September 30, 2022

Re: Variance Request
The Montgomery Grove
City of Montgomery

The City received a variance request from the owners of the Montgomery Grove Food Truck Park, located at 22016 Eva Street. The Developer is requesting the following variance from the City's Code of Ordinances:

MONTGOMERY GROVE PARKING LAYOUT

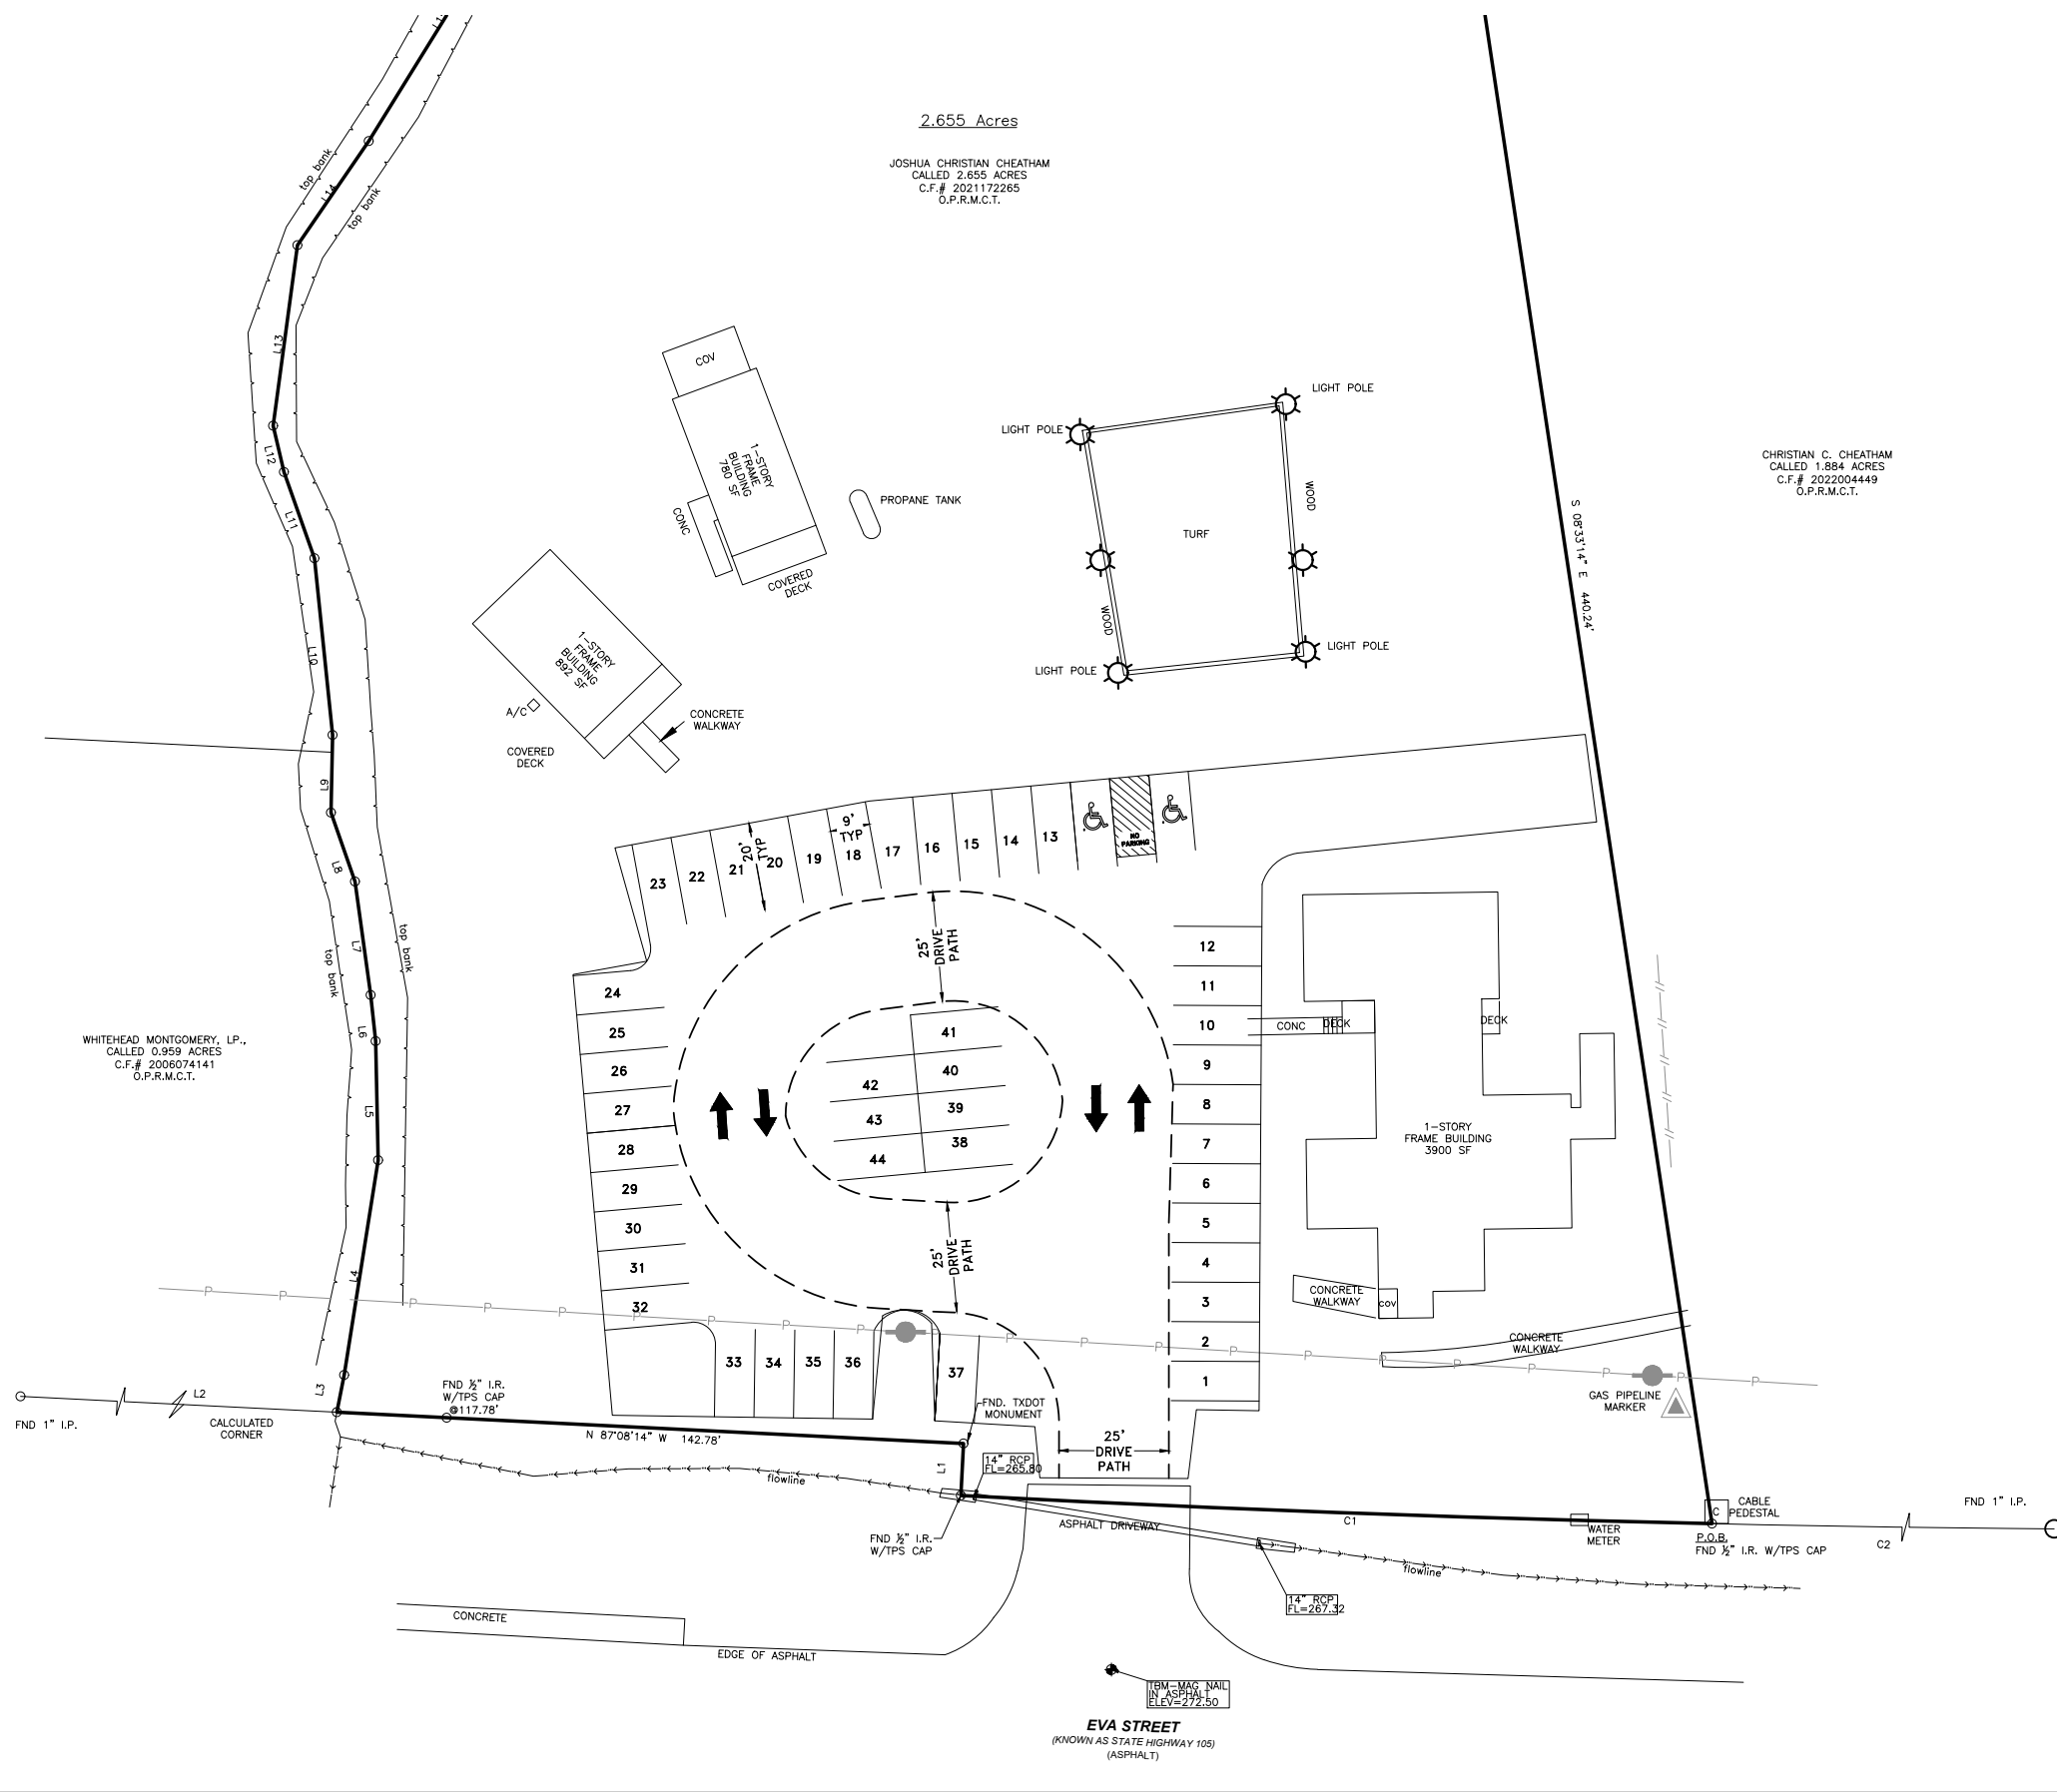
We recommend the request be tabled until additional information is received including an escrow agreement is entered into and engineering plans provided showing the full scope of the new improvements and their impact that follow the current City Ordinances. Based on planned improvements stated by the developer (enclosed), the developer plans to install additional lighting which will require a lighting plan and construction of a stage and other structures in an area that is likely within the floodplain. Additionally, the information recently provided by the developer showing the proposed parking layout is contradictory regarding the location and number of ADA spaced.

PRELIMINARY SITE PLAN

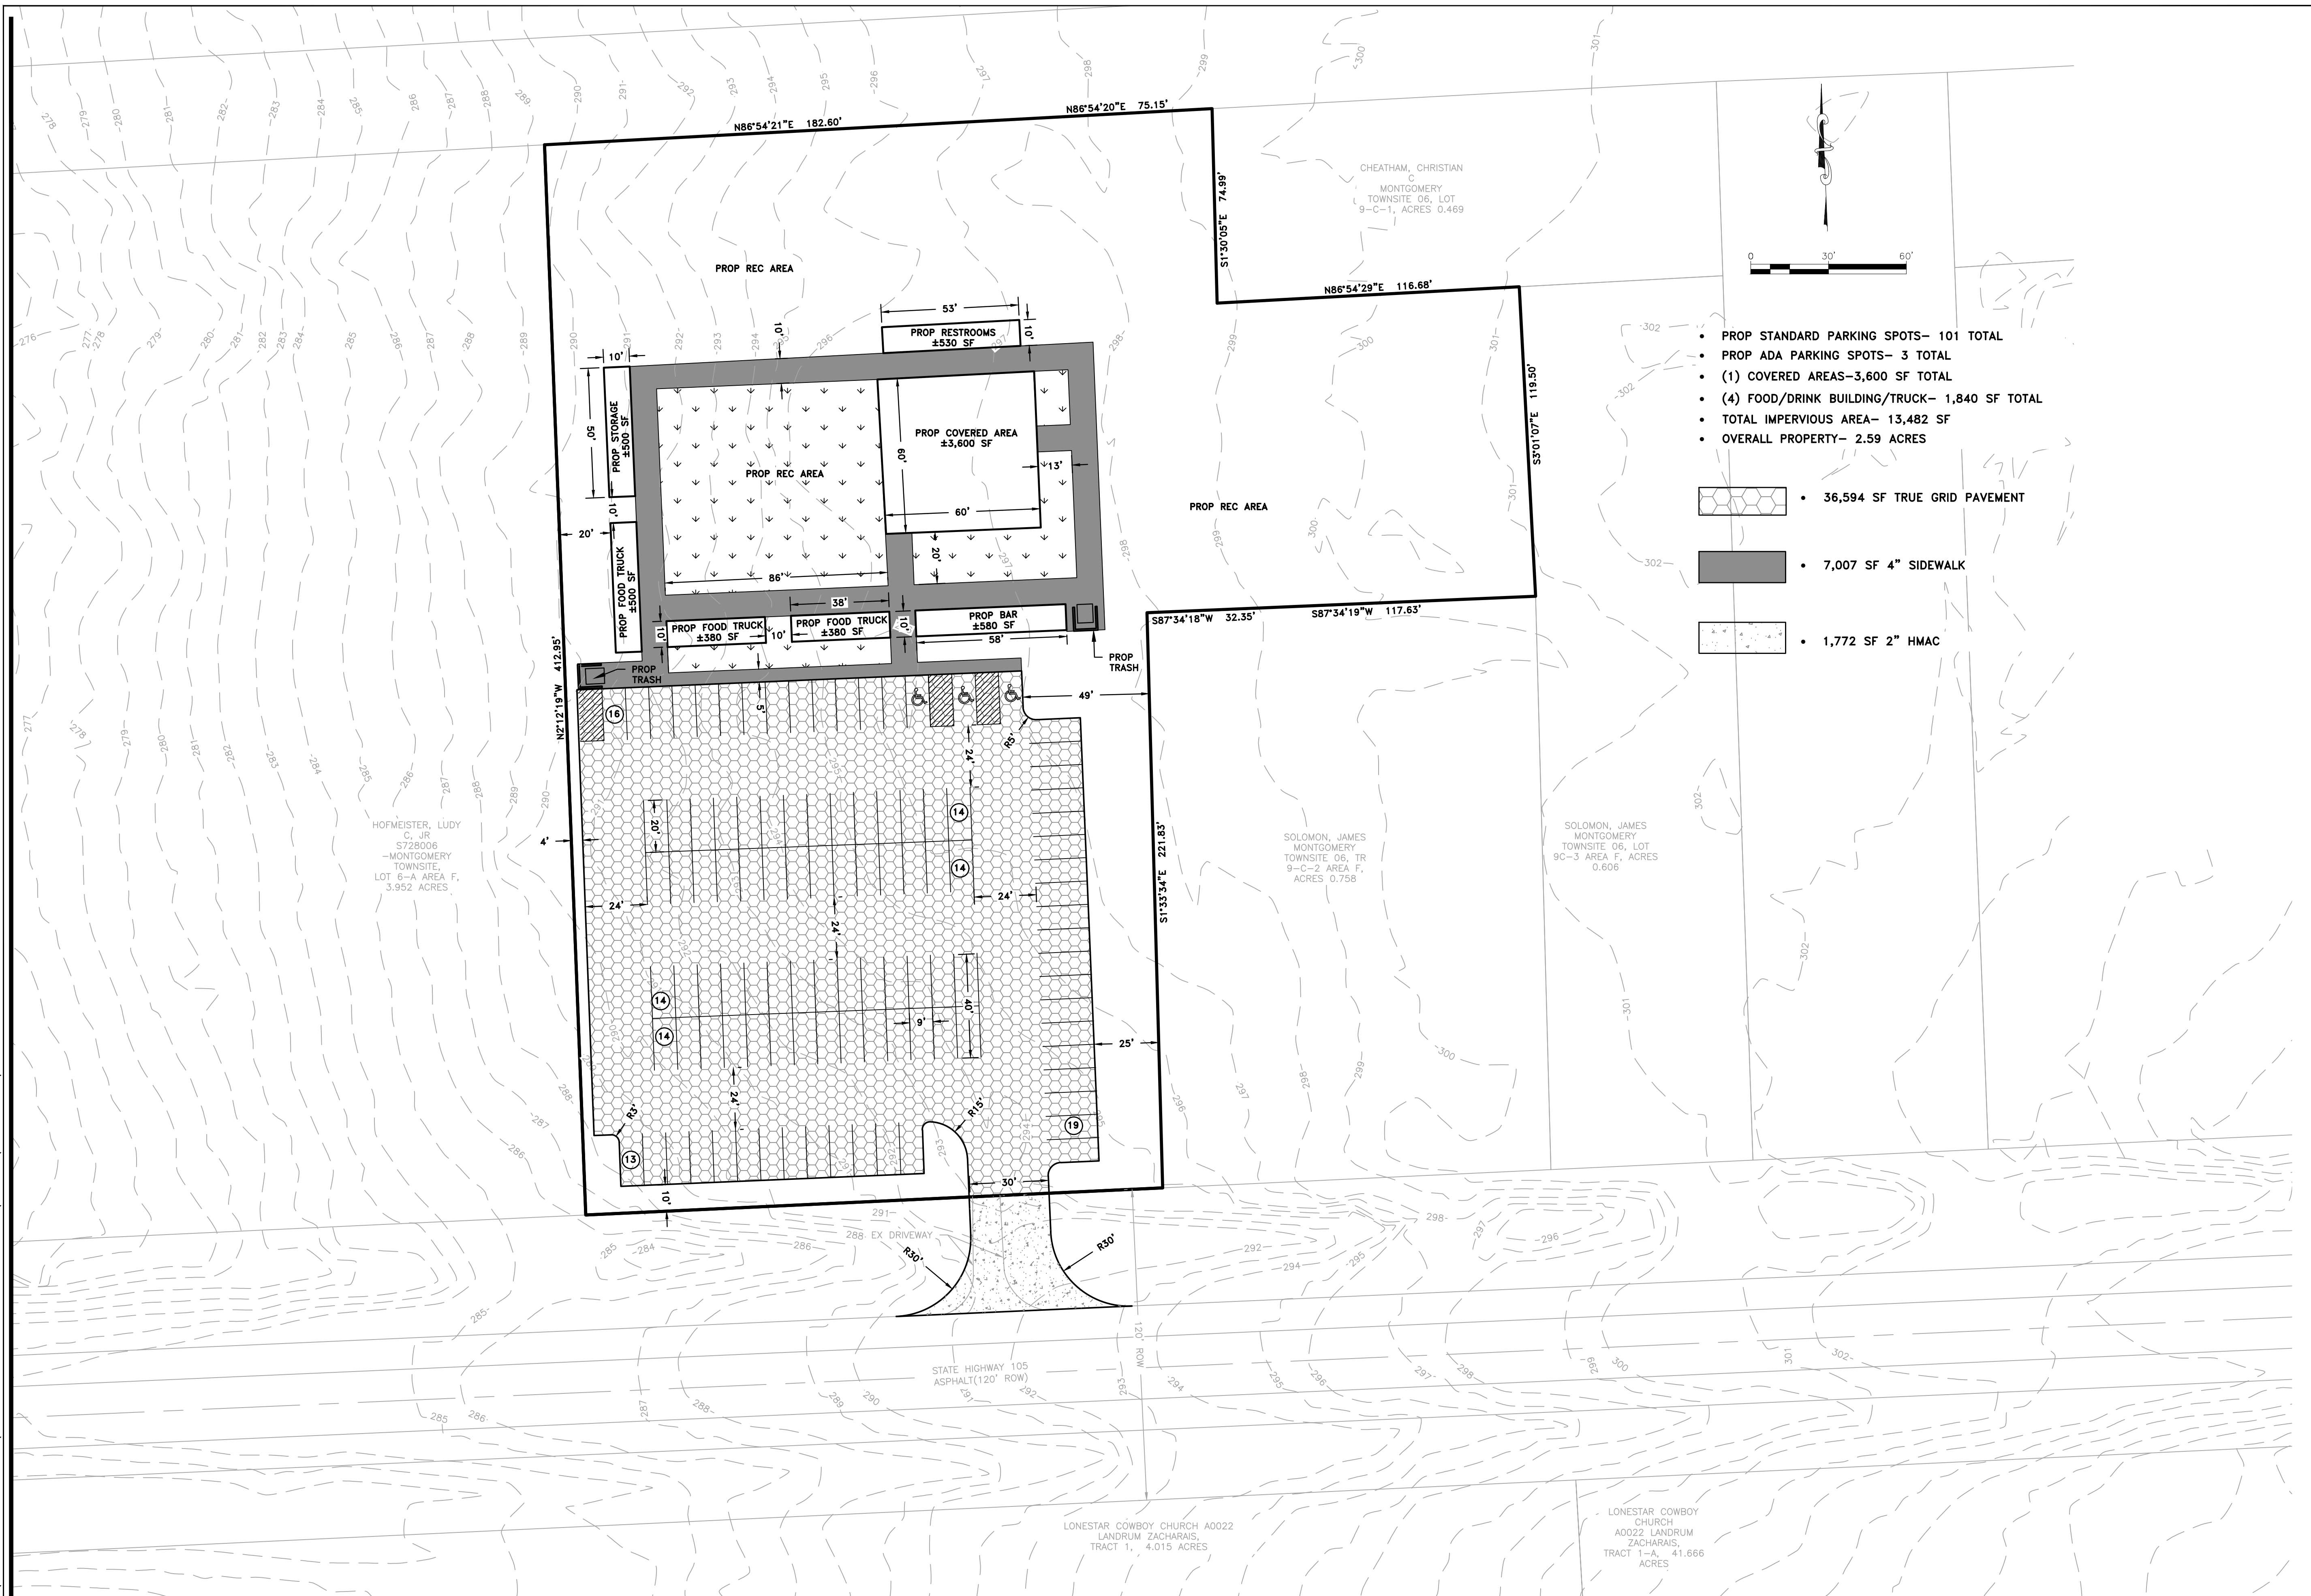
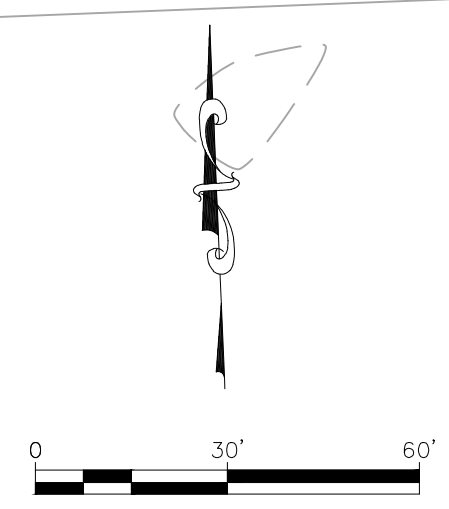
We offer no objection to the concept of using permeable paving system on the parking areas and secondary drive aisles. However, we would recommend the main drive aisle off the driveway be constructed of asphalt or concrete for a total length of approximately 75’ from the edge of pavement of SH-105 to allow for adequate deceleration space. The Developer will need to submit final details and specifications including a drainage analysis confirming detention is not required with his construction plans for review and approval by the City.
